To: Jack Varozza, City of Roseville

From: Raina Joby and John Gard, Fehr & Peers

Subject: Evaluation of Access and On-Site Circulation for the Proposed Hayden Commercial Center

The study evaluates site access and on-site circulation elements against requirements prescribed in the *City of Roseville Design Standards* (City of Roseville, 2025) based on the latest project site plan (*Hayden CSP- Concept 10, Milestone Imagineering, Inc., Sep 24, 2025*).

FIGURE 6

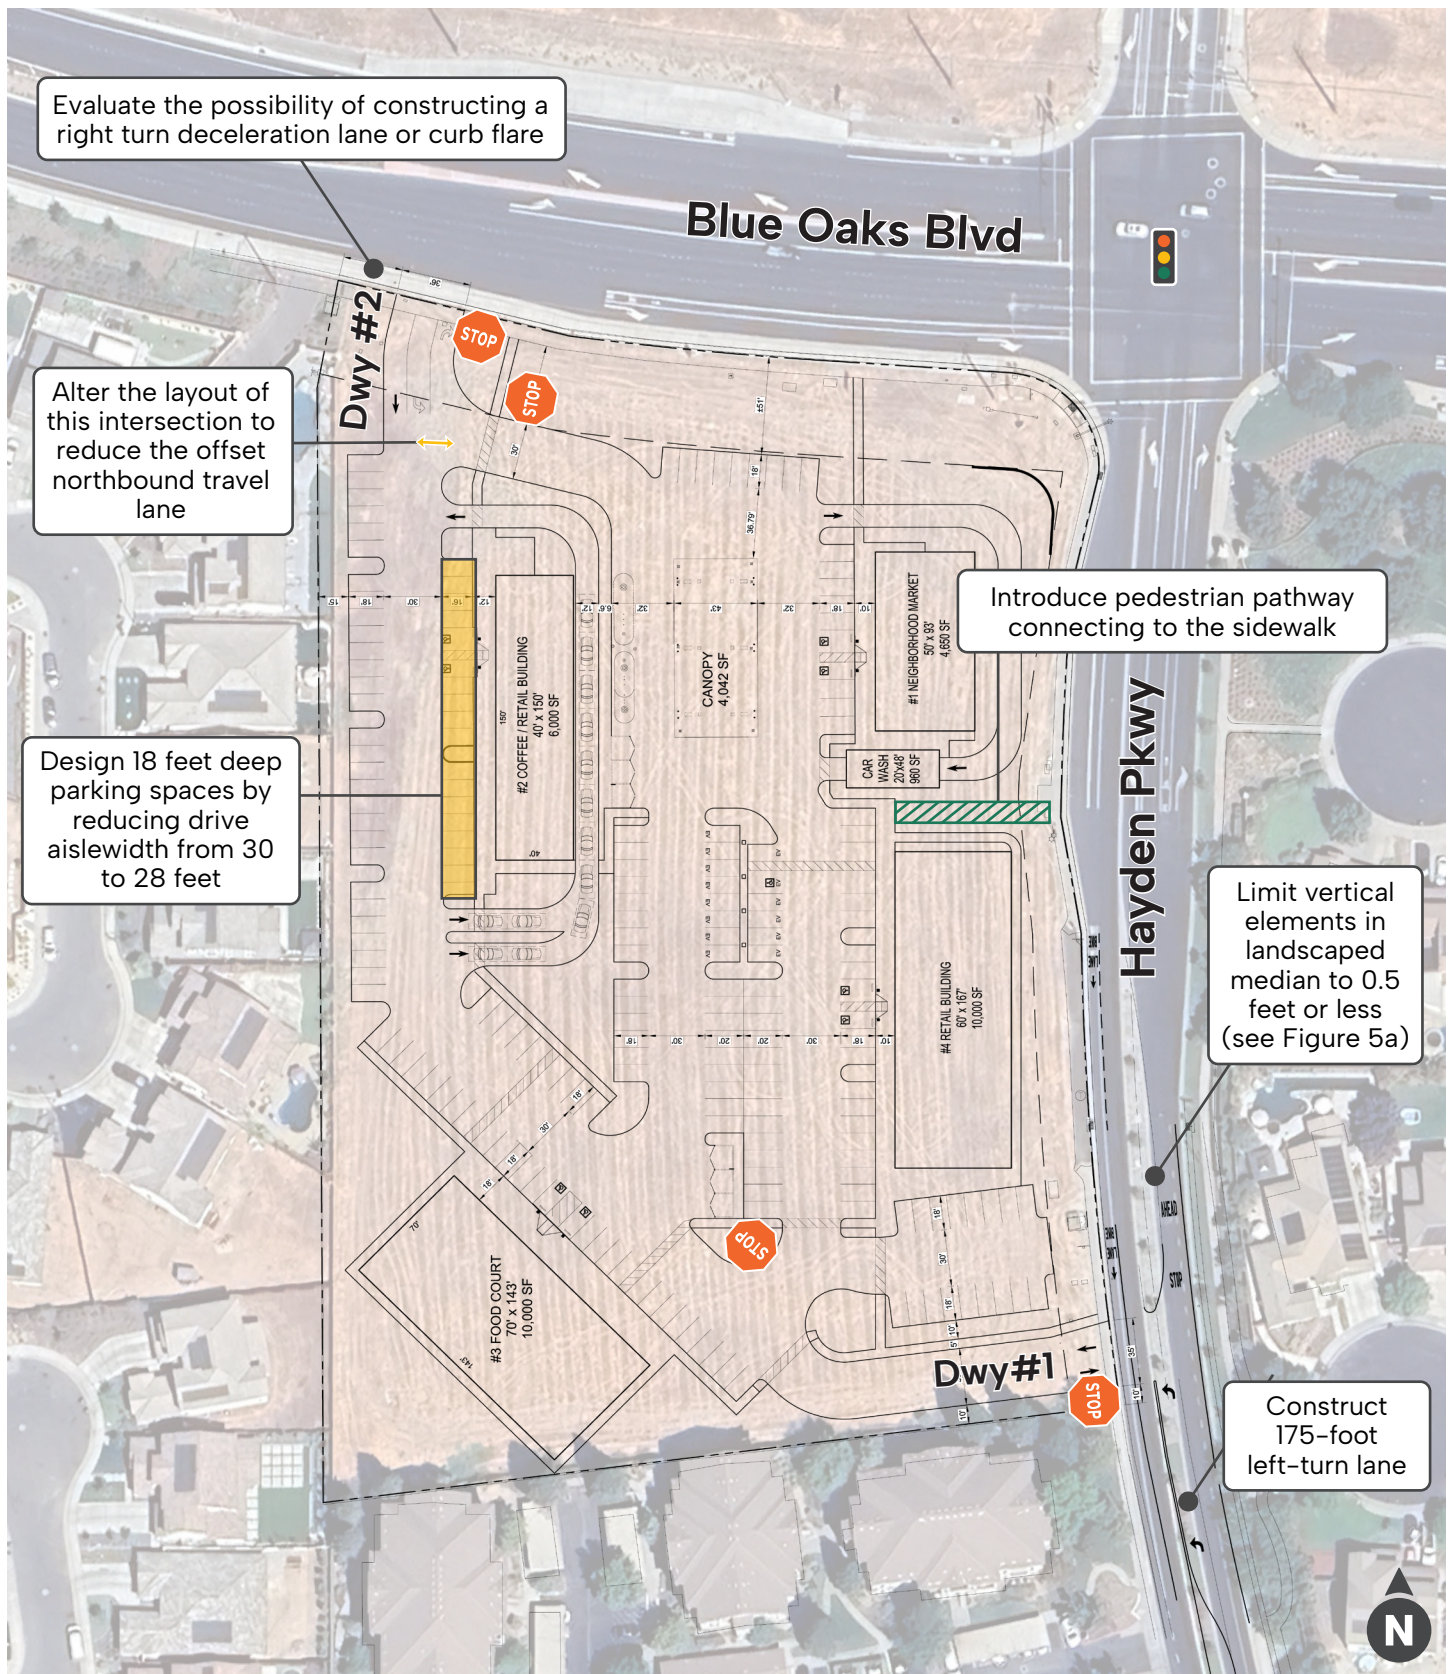
Recommendation 6: At the first two internal intersections within the site, install stop signs on the side-street approaches (see Figure 6).

The site plan provides three pedestrian pathways to access the project site from the sidewalks along Blue Oaks Boulevard and Hayden Parkway. These pedestrian pathways are located adjacent to the project driveways and close to the crosswalks on the west and south legs of Blue Oaks Boulevard / Hayden Parkway. However, a connection is not provided between the gas station and retail building to where the bus stop shelter pad would be located.

Recommendation 7: Add a pedestrian connection between the gas station and retail building to connect the site to the sidewalk adjacent to the bus stop on Hayden Parkway (see Figure 6).
